REMARKS

This paper is responsive to non-final Office Action dated January 14, 2004. Claims 1-39 were examined. Claims 25 and 27 stand rejected under 35 U.S.C. § 112, second paragraph, as being indefinite. Claims 1, 3, 4, 6, 7, 15-20, 23, 31, and 35-39 stand rejected under 35 U.S.C. § 102(e) as being anticipated by U.S. Patent No. 6,623,185 to Peragine. Claims 13, 33, and 34 stand rejected under 35 U.S.C. § 103(a) as being unpatentable over Peragine. Claims 2, 5, 8-12, 14, 21, 22, 24, 26, 28, 29, 30 and 32 are objected to for depending from a rejected base claim.

FIG. 18

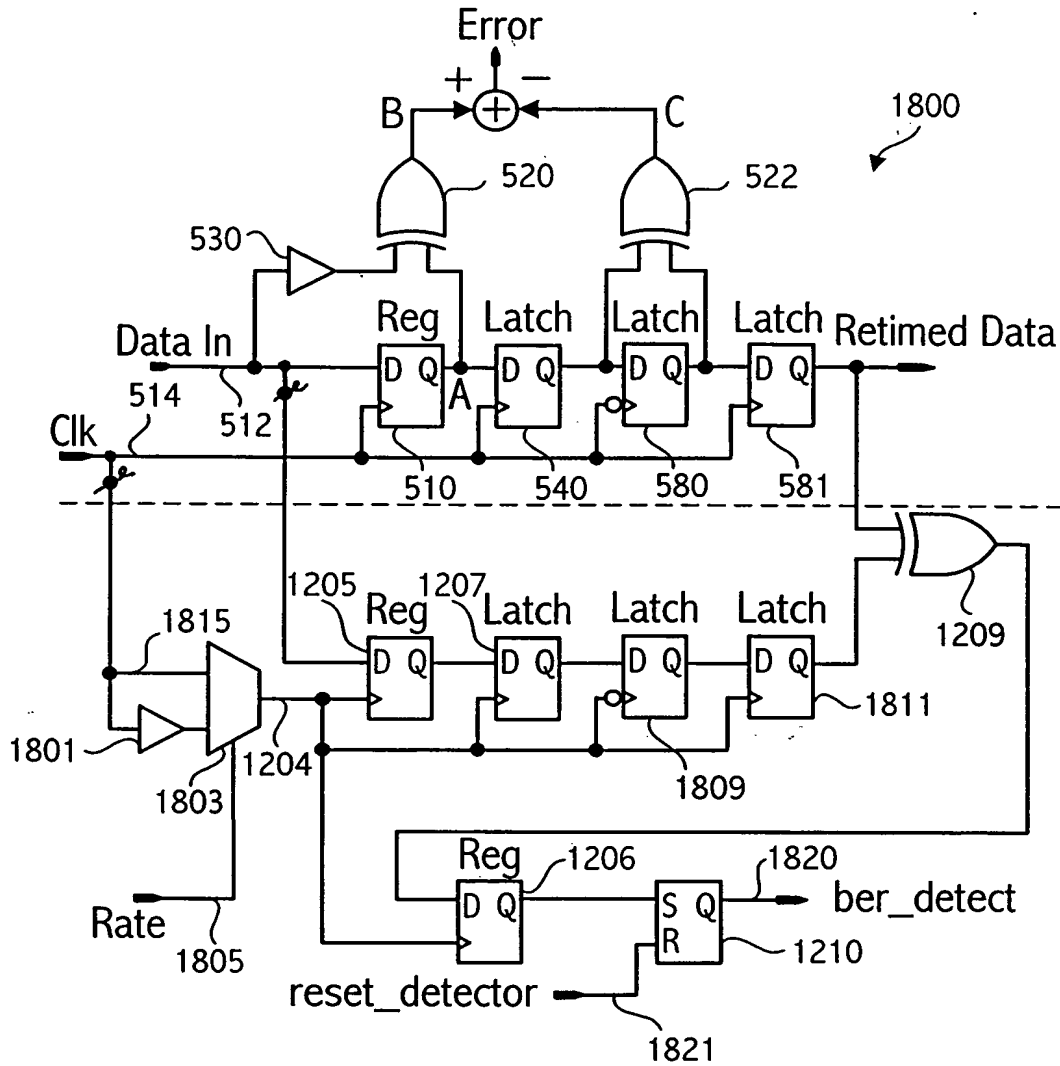
Figure 18 has been changed to couple register 1205 to node 512 and to couple delay path 1815 to clock signal 514, consistent with the specification. No new matter has been added.
